**Assessment of the  
Jabiluka Project**

Report of the Supervising  
Scientist to the World  
Heritage Committee

Johnston A & Prendergast JB 1999. *Assessment of the Jabiluka Project: Report of the Supervising Scientist to the World Heritage Committee*. Supervising Scientist Report 138, Supervising Scientist, Canberra.

**Figure 2.4.1** Variation of saturated vapour pressure (upper graph) and absolute humidity (lower graph) with temperature at atmospheric pressure  $P=100$  kPa

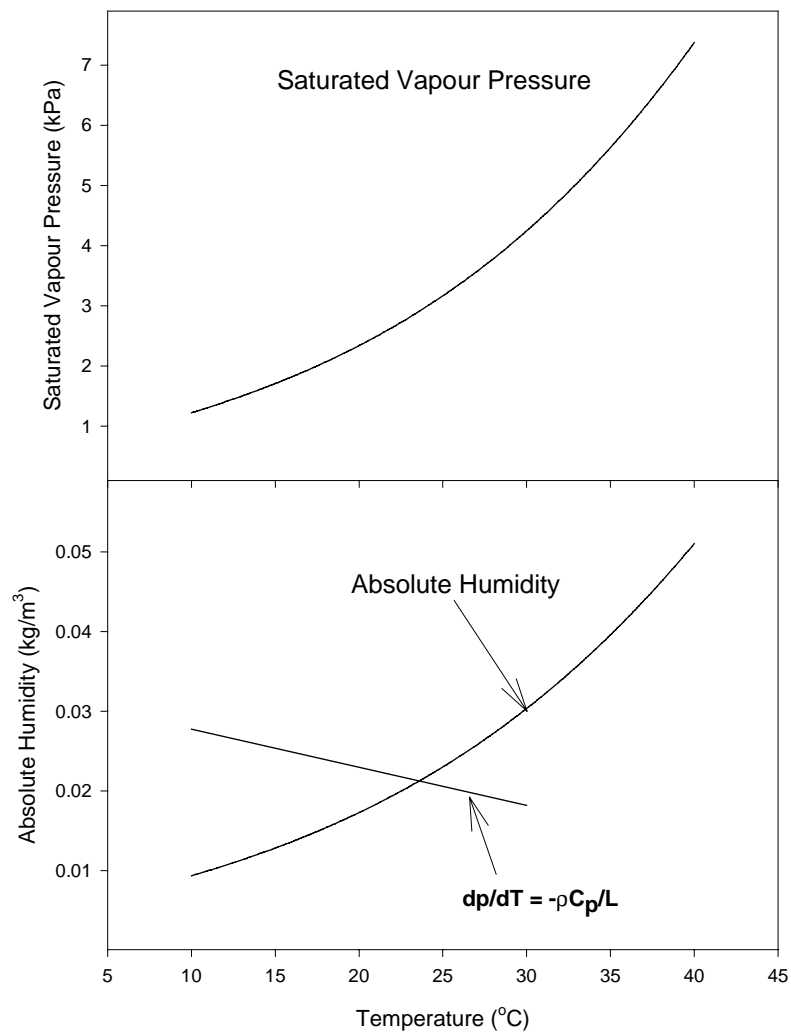
where  $\Delta p$  is the change in humidity,  $L$  is the latent heat of vaporisation,  $\rho$  is the density of air and  $C_p$  is the specific heat of air. Using  $L = 2.43 \times 10^6 \text{ J/kg}$  (Kaye & Laby 1978, p 235),  $\rho = 1.149 \text{ kg/m}^3$  (Kaye & Laby 1978, p 18) and  $C_p = 1010 \text{ J/kg/}^\circ\text{C}$  (CRC 1995, p 6-1), the decrease in temperature resulting from the vaporisation of the water would be  $16^\circ\text{C}$ . As can be seen from figure 2.4.1, the absolute humidity (ie fully saturated) at  $14^\circ\text{C}$  is about  $0.012 \text{ kg/m}^3$ , a figure considerably less than the initial vapour density. Hence, the target evaporation figure cannot be achieved.

For 60% relative humidity,  $p_0 = 0.0182 (\text{kg/m}^3)$  at  $T_0 = 30^\circ\text{C}$ . This line is shown in figure 2.4.1. It intercepts the graph of absolute humidity at about  $23.6^\circ\text{C}$  which, as proposed by Wasson et al (1998), is the wet bulb temperature (estimated as  $23.8^\circ\text{C}$  from the data in CRC (1995) p15–22). At this temperature the absolute humidity is  $0.0213 (\text{kg/m}^3)$ . Thus the maximum quantity of water that can be evaporated is

$$p = 0.0213 - 0.0182 = 0.0031 (\text{kg} / \text{m}^3).$$

This value is about 40% of the design value presented in Appendix J of the draft EIS.

These observations, however, do not imply that a major error exists in the proposal put forward for water management at the Jabiluka mine. If the latent heat of evaporation were to be supplied (for example, by standard humidifiers) there would be no need to take the above drop in temperature into account and the volume of water that could be evaporated would remain that estimated in the EIS and the PER. The Supervising Scientist consulted the engineer who advised ERA on this issue (Mr Douglas Rudd, Kinhill Pty Ltd) who advised that the calculations were provided to indicate the capacity of the ventilation system to dispose of additional water through evaporation. It was recognised that energy input via heaters, hot air blowers or staged misting/humidifiers would be required to achieve the full indicated disposal volume. These issues were, however, matters to be dealt with at the detailed design stage of the project when the potential of this method of water disposal could be evaluated (ie a cost benefit analysis) in a comparison with other methods such as increasing the area of the retention pond.

However, the power consumption of such a system could be considerable. The power consumption of a humidifier designed to provide the latent heat of evaporation will be determined by the operating conditions in the Dry season when the maximum evaporative capacity exists. To estimate the power required, the data presented in table J.2 of Appendix J of the draft EIS have been used.

The area of the retention pond would need to rise from 9 ha to approximately 13 ha to provide the required evaporative capacity if no evaporation occurs in the ventilation shafts. This area is small compared with the total area of retention and tailings ponds proposed in the original JMA proposal and is only 2% of the disturbed area at the nearby Ranger mine. The environmental impact arising from such an increase, should it need to be part of the project, is, therefore, not considered to be significant.

**Figure 3.4.1** Cusum plot for the annual rainfall records at Oenpelli showing low average rainfall from 1932–1952 and high average rainfall from 1970–1984

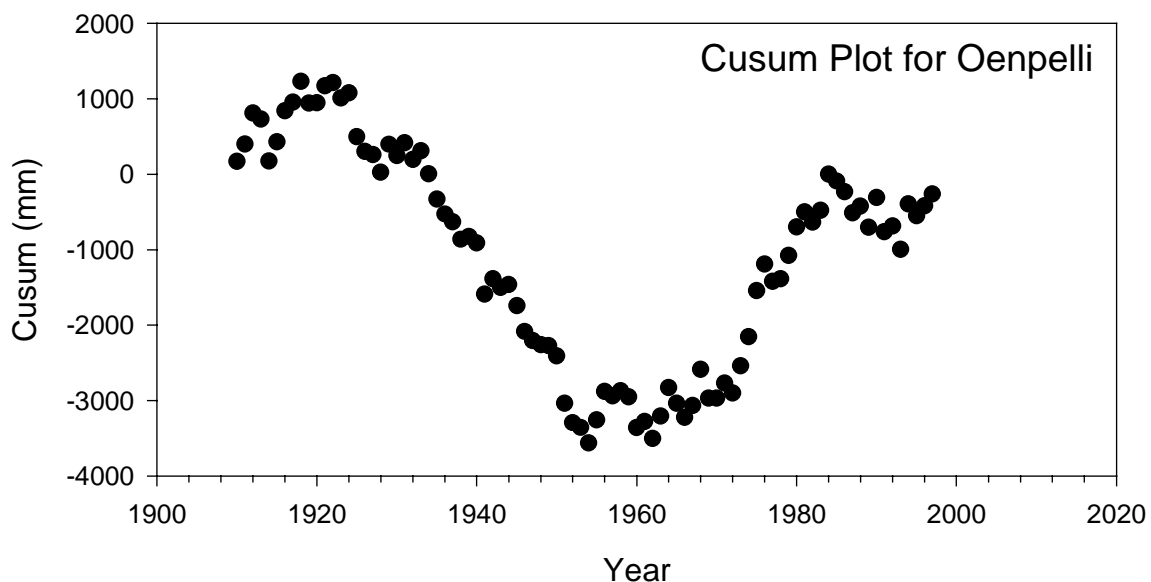
The *cusum* analysis for the Oenpelli data set, including rainfall records from 1991–1998, is shown in figure 3.4.1. It can be shown (eg Mittag & Rinne 1993) that the gradient of the *cusum* graph at time  $t$  is the difference between the mean at that time and the long-term mean. The data in figure 3.4.1, therefore, show that at Oenpelli there have been two extended periods in the past 87 years during which the mean annual rainfall for the period has been significantly different from the long-term mean annual rainfall. From 1932–1952, the mean rainfall was about 1220 mm, lower than the long-term mean by about 13%. From 1970–1984 the mean rainfall was about 1600 mm, higher than the long-term mean by about 15%. It is clear that such decadal-scale variation in mean rainfall could have a significant impact on hydrological modelling for the Jabiluka mine site and needs to be taken into account in the design of the water management system.

**Figure 3.4.2** Average annual rainfall from Oenpelli 1911–1997, showing a 10-year moving average and linear trend of 1.7 mm pa

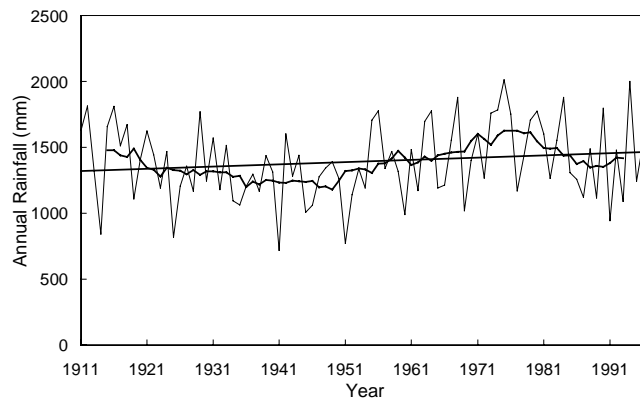
Jones et al (1999) analysed the Oenpelli rainfall record to determine historical rainfall trends and rainfall variability. The results are presented in figure 3.4.2. Significant decadal-scale variability is demonstrated by the 10-year moving average and a trend of 1.7 mm pa that is not statistically significant.

- Analysis of the historical rainfall record at Oenpelli reveals an upward trend of 1.7 mm per annum in the mean annual rainfall that may be attributed to global warming and which should be added to the model predictions. The observed trend is not statistically significant but the adoption of a precautionary approach implies that the significance of this possible trend should be assessed in hydrological modelling of the Jabiluka project. However, stochastic rainfall series modelling, based upon the Oenpelli rainfall record, also exhibits a similar trend and it is concluded that there is no need to include this effect explicitly in a climate change scenario.

**Figure 4.2.1** Estimates of storage capacity required as a function of exceedence probability over the 30-year mine life under current climatic conditions

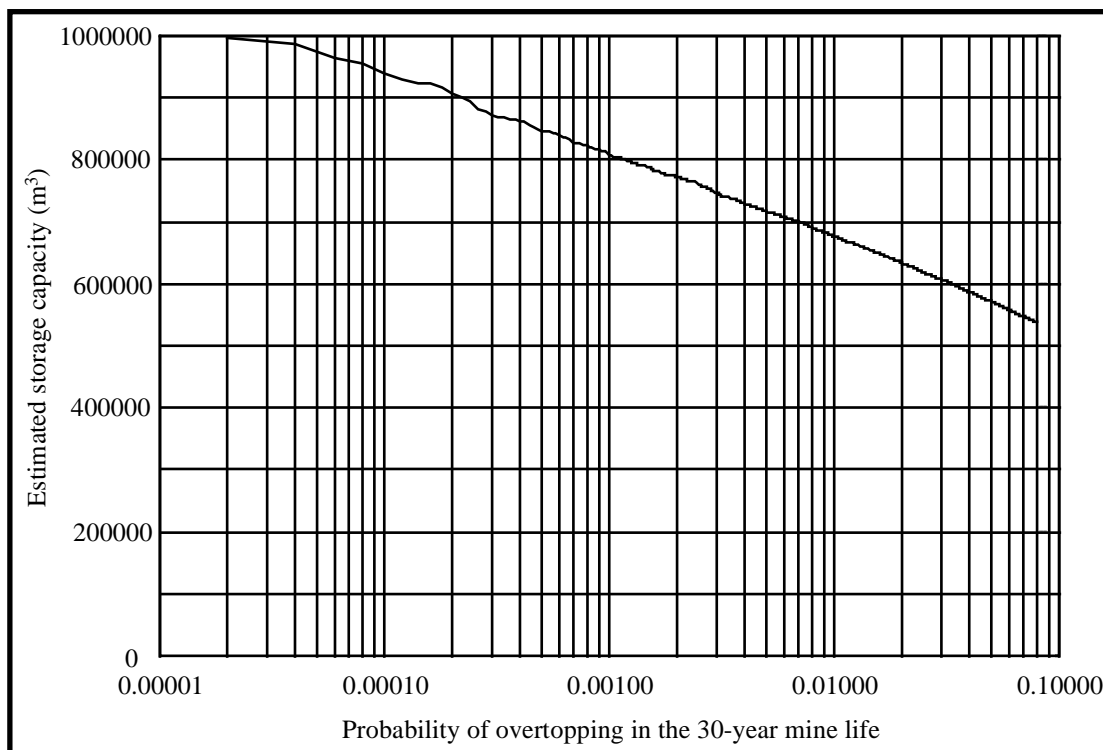
Figure 4.2.1 shows the estimates of storage capacity required as a function of exceedence probability over the life of the mine. The volume of pond proposed by ERA in the PER was 810 000 m<sup>3</sup>. (This is based upon a 9 ha pond of depth 9.5 m (PER p 4–52) of which 0.5 m is freeboard required to take into account wave action and is therefore not available for storage except under emergency conditions.) The data in figure 4.2.1 indicate that the probability of this storage capacity being exceeded in the life of the mine would be about 1:1000. Based on these simulations, the estimate of storage capacity required to achieve an exceedence probability of 0.01% (1 in 10 000) over the 30-year mine life is 940 000 m<sup>3</sup> (an equivalent depth of 10.4 m in the 90 000 m<sup>2</sup> storage area).

The probability of the pond overtopping in the absence of contingency measures can be derived from figure 4.2.1 using a volume equal to the total volume of the pond including the freeboard volume. For a total depth of 9.5 m (PER, page 4-52) the pond volume would be 855 000 m<sup>3</sup>. From figure 4.2.1, the exceedence probability for this volume over the life of the mine is about 0.0005 or 5 in 10 000.

**Figure 4.2.2** Annual rainfall (September–August) and accumulated water volumes for a model simulation using actual rainfall and evaporation from September 1972 to August 1998

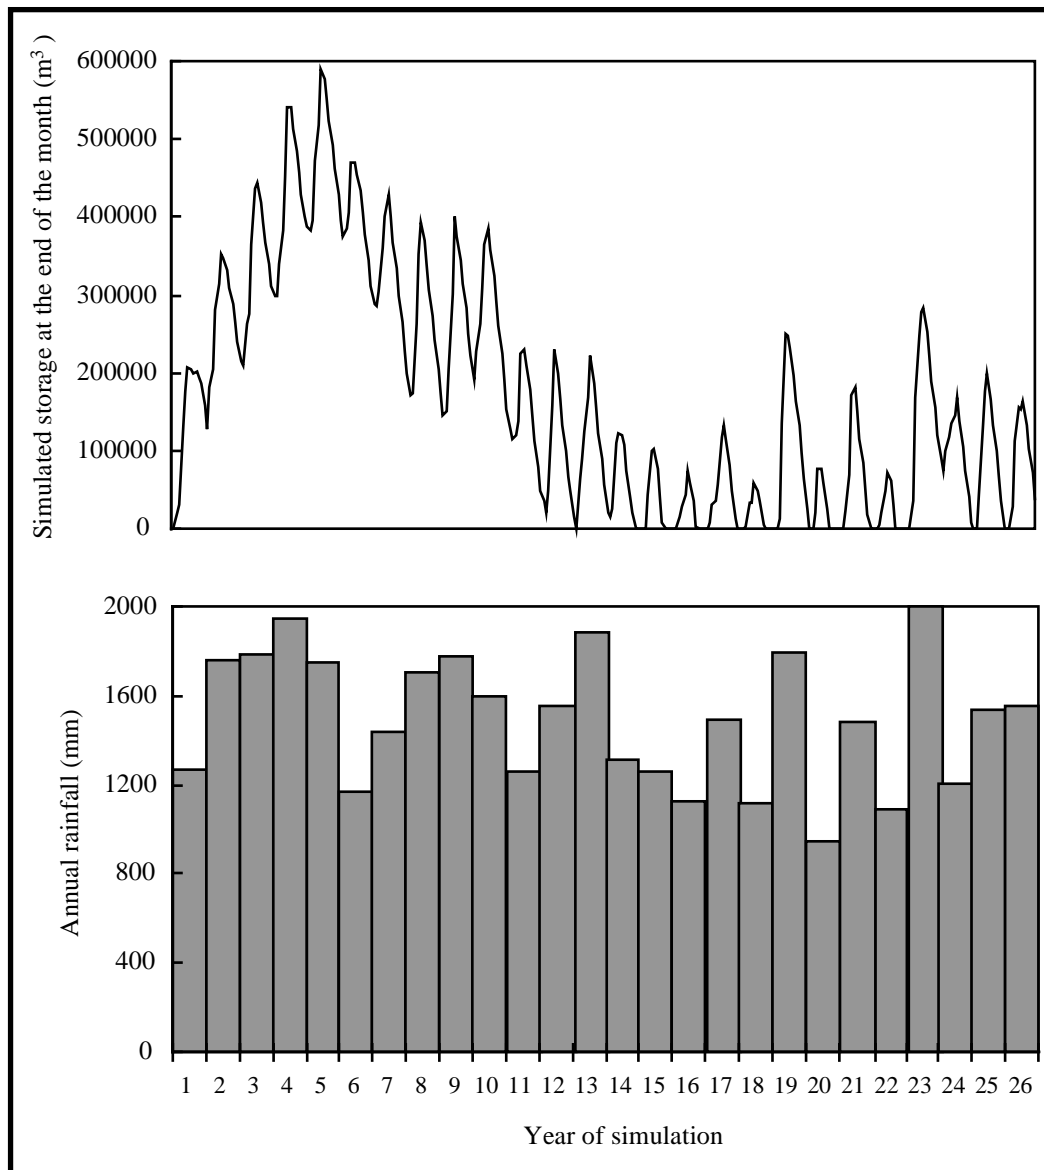
The results of these calculations are presented in figure 4.2.2. The plots show the annual rainfall in the Oenpelli record for the period and the accumulated water volume calculated by the model at the end of each month during the period.

The data presented in figure 4.2.2 show that the largest volume of accumulated water calculated by the model for the period is 594 000 m<sup>3</sup>. A storage capacity of about 600 000 m<sup>3</sup> would, therefore, have been required to avoid exceedence at any time during the 26-year period using the actual recorded rainfall. Note that this volume is much lower than would be required for, say, a 1:10 000 exceedence probability if one used the rainfall records for this period as the basis for a Monte Carlo simulation of the type described in section 4.2.3.

The largest accumulated volume of water occurred in the fifth year of this simulation following a steady build-up during the previous four years. After this peak volume is reached, the maximum volume required decreases in subsequent years until, following the simulated tenth year of operation, the maximum capacity required in all years is less than half the maximum value. Indeed, on a number of occasions, the volume of stored water reduces to zero, implying that water would need to be imported from the bore field to enable continuation of the milling process.

Examination of the annual rainfall record presented in figure 4.2.2 shows that this characteristic, which is typical of all simulations, is not attributable to an unusually high sequence of wet years in the early part of the rainfall record. Rather, the observed pattern is due to the gradual increase in assumed losses due to evaporation in the ventilation system (and, to a much less significant extent, losses due to ore wetdown and plant washdown) which only reach their maximum value in year 10 of operation. The water losses assumed in the calculations, taken from the PER Appendix B1 are given in table 4.2.4.

in accumulated water losses from the water management system between this scenario and that outlined in table 4.2.4 is about 300 000 m<sup>3</sup>. Hence, the maximum storage capacity required in the simulation illustrated in figure 4.2.2 would be reduced by about 50%. Similarly, it is likely that if the full simulation of the water management system were repeated using pond evaporation rather than evaporation in the ventilation system, the capacity required to achieve an exceedence probability of 0.01% over the life of the mine (see section 4.2.3) would be reduced by about 30%.

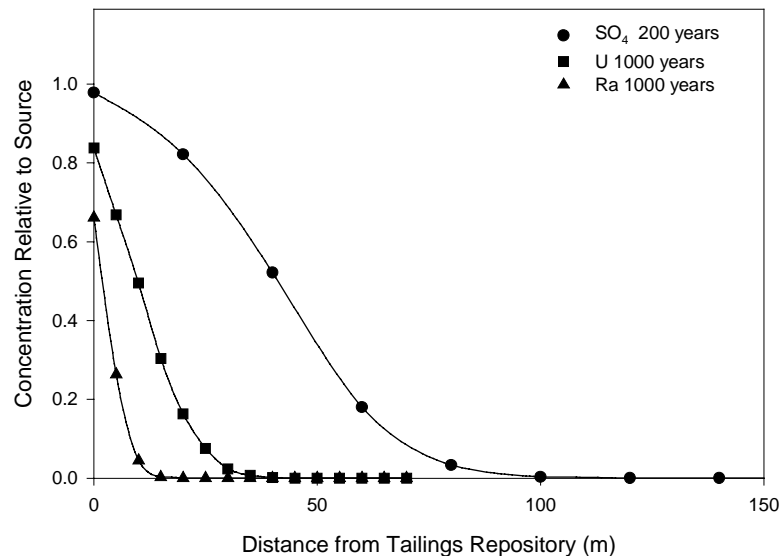
In the lower permeability aquifer to the east of Jabiluka, the concentrations of non-reactive solutes reduce to negligible levels 200 m from the mine. For example, the median sulphate concentration profile relative to the 'source' concentration immediately downstream from the silos is given in figure 5.3.5. This solute profile was obtained for a 200 year run with a tailings permeability of  $10^{-9}$  m/s and an aquifer conductivity of 0.01 m/d. If the tailings concentration of sulphate, which is the most mobile of the solutes considered, is 20 000 mg/L (table 5.3.1), the three-dimensional solute transport model shows that the concentration reduces to 2000 mg/L immediately downstream of the silo (Kalf & Dudgeon 1999). The data in figure 5.3.5 show that the median sulphate concentration reduces to 20 mg/L at a distance 100 m downstream. Given the large additional dilutions through the surficial aquifer before the contaminant can reach Swift Creek, then additional dilution in the creek itself, Kalf and Dudgeon (1999) conclude that there is negligible potential for contamination of surface streams to the east.

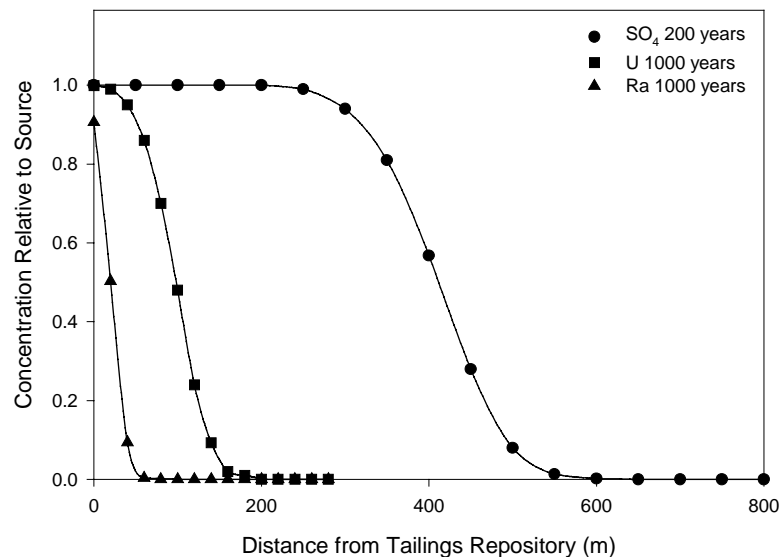
The transport of solutes to the west is calculated to be somewhat more rapid because of the greater permeability of the aquifer there. The velocities east of the divide in the sandstone are between  $5 \times 10^{-5}$  and  $5 \times 10^{-6}$  m/day, whilst in schists to the west the range is  $5 \times 10^{-4}$  to  $5 \times 10^{-5}$  m/day. The results obtained for the migration of sulphate, uranium and radium to the west are shown in figure 5.3.6. These data indicate a probable migration distance of 500 m after 200 years for sulphate, although greater distances are possible (Kalf & Dudgeon 1999). Again, the three dimensional solute transport model shows that for a tailings permeability of  $10^{-9}$  m/s, the sulphate 'source' concentration immediately downstream from the mine void tailings would be about 2000 mg/L. The data in figure 5.3.6 show that the median concentration of sulphate would drop to less than 20 mg/L about 500 m downstream. This water would be entering an area of already very poor quality water (see section 5.3.1) where natural sulphate concentrations are in the range 1500–7000 mg/L so that the impact of the migration of water from the tailings repository would be negligible. In addition, the floodplain is underlain by low permeability clays (East et al 1992) which act to limit any potential upflow of the groundwater into surface waters.

The data in figure 5.3.6 indicate that uranium is likely to travel up to 200 m in a westerly direction at which point the concentration would be reduced to less than 1 mBq/L, a concentration that is significantly less than natural concentrations in the region. The Monte Carlo calculations show that migration up to 1200 m is possible but with a very low probability. Kalf and Dudgeon (1999) conclude that radium and uranium will remain at background levels in the floodplain.

- The permeability of the Cahill Formation schists west of the orebody is significantly greater than that of the Kombolgie sandstone to the east. For this reason, it is recommended that the additional tailings silos should be excavated in the Kombolgie sandstone east of the orebody, as is currently planned by ERA. This choice of location will minimise potential environmental impacts.
